14 September 2026
Our Ref: 25BRT0479 LT02
Council Ref: A007025195

**RE: 842 Waterworks Road, The Gap – Work-Stores/Storage Sheds & Self-Storage Facility
Transport Engineering Report – Response to Council’s Information Request**

Colliers has been engaged by Pradella Property to prepare a Transport Engineering letter to respond to Brisbane City Council’s (BCC’s) Information Request (IR) dated 30 June 2026. This IR relates to a Development Application submission (Ref: A007025195), relating to a proposed warehouse development located at 842 Waterworks Road, The Gap.

DRAWING TITLE:	GROUND FLOOR PLAN
SCALE:	1:350@A3
DRAWN:	NR
DATE:	11/09/2026
DWG No.	DA2.01
ISSUE	A

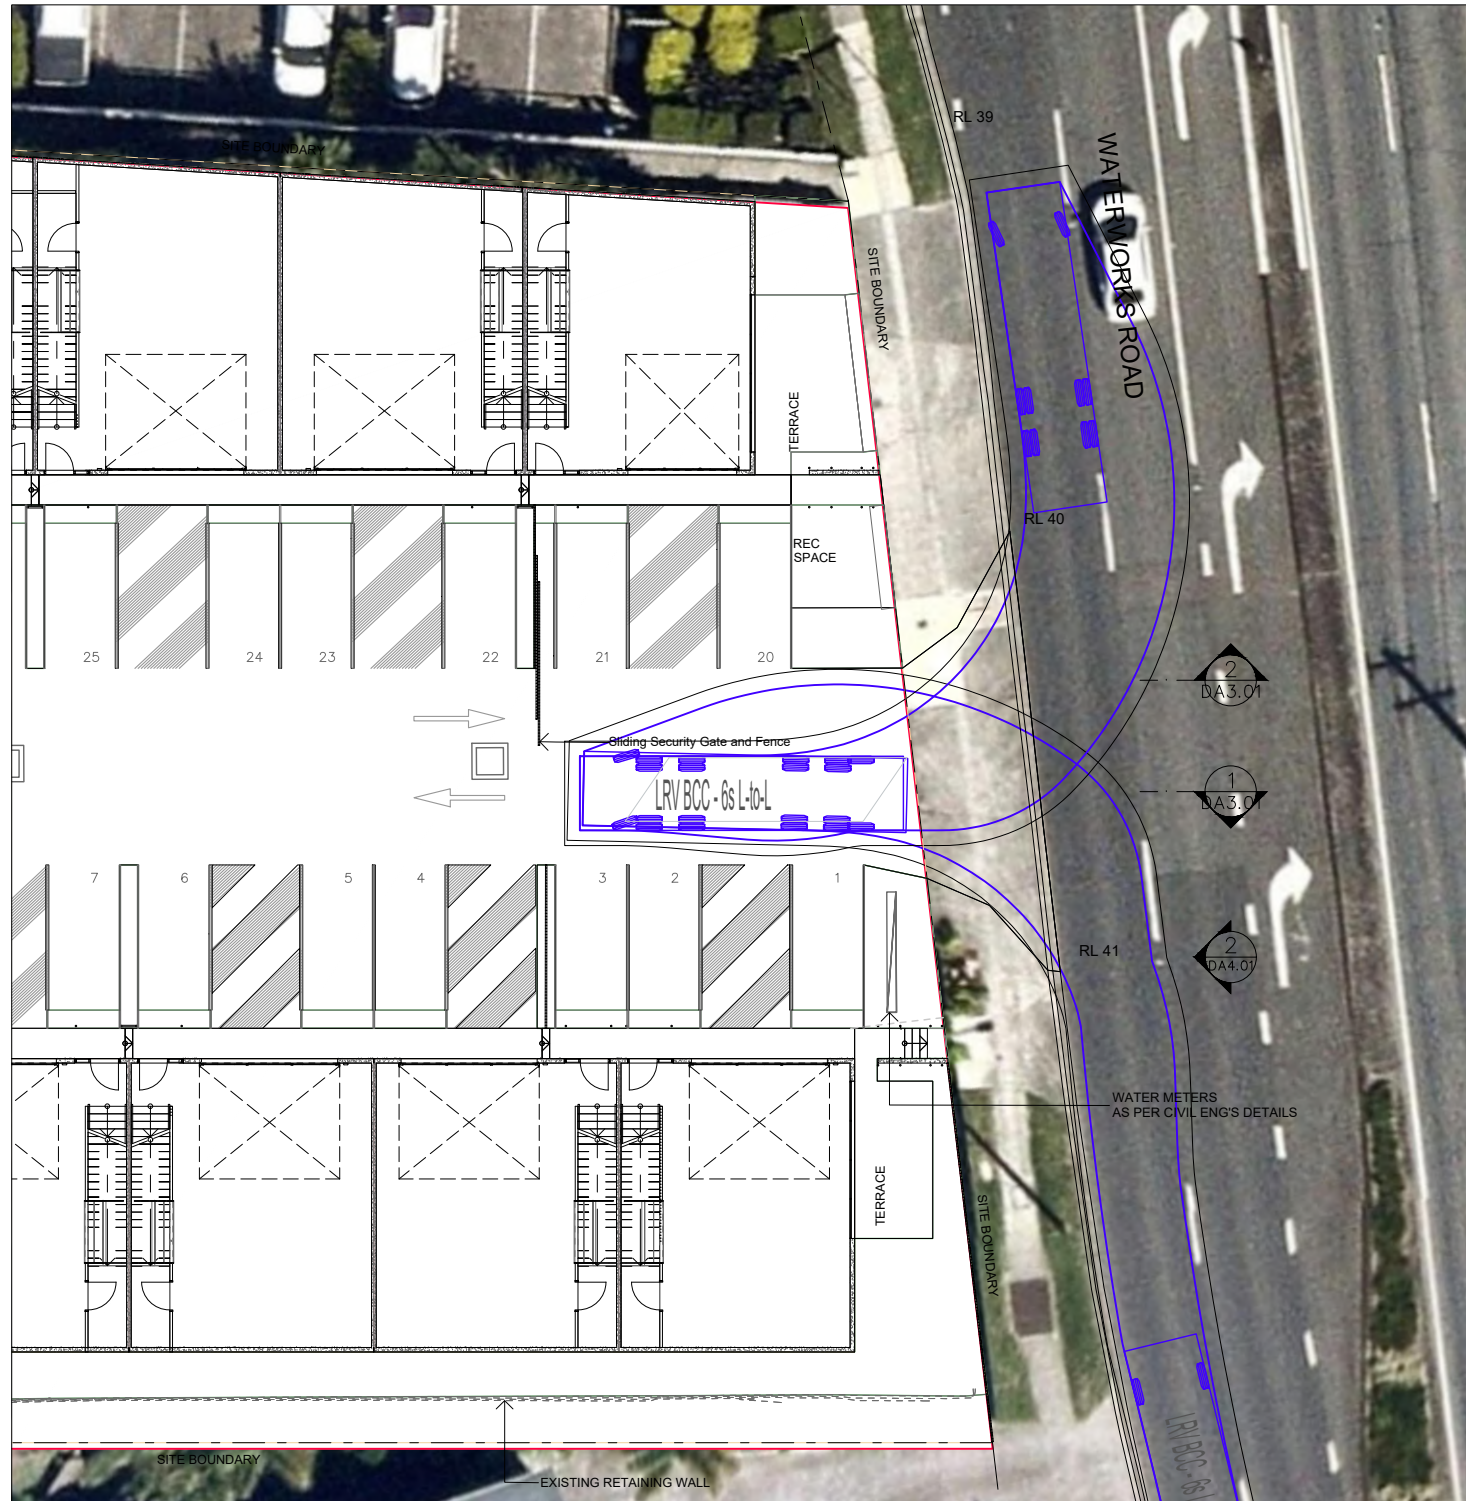
A review of the ‘Ground Floor Plan’ has identified that the entire two-way aisle/carriageway trafficked by the RCV is less than 6.5m. Furthermore, a review of the ‘Colliers – Service Vehicle Swept Path Analysis’ has identified that the 10.52m Front-Lift Loading RCV clearance envelope conflicts with a parking bay and built

- a) Demonstrate the entire two-way aisle/carriageway trafficked by the RCV is 6.5m wide, inclusive of the T-Head turnaround area.*
- b) Utilising amended architectural plans provide an RPEQ certified swept path analysis which demonstrates a 10.52m Front-Lift Loading RCV (As per BSD-3009) as specified in Table 3 of the Refuse PSP can safely and efficiently service the development whilst utilising a lock-to-lock time of 6.00s, curb-to-curb turning radius of 9.757m and 0.5m clearance envelope.*

In response to BCC's information request, the development has reduced car parking bay #17 to a 5m long small car bay and reduced the landscaping area adjacent to car parking bay #34 to facilitate access for a 10.7m LRV and 10.24m BCC Rear Loading RCV.

Whilst the development generally retains a 6.5m aisle width to facilitate two-way operation in accordance with Table 12 of the BCC TAPS PSP, Colliers notes that a short section in front of parking bays #18 and #19 has been provided with a 6.2 m aisle width.

Given that two-way operation is not necessary within this section, considering the limited traffic associated with the two car parking spaces and the single roller door serving Unit #9, the proposed 6.2 m aisle width is considered appropriate. The proposed 6.2m width exceeds the 4.5m minimum required for one-way operation.
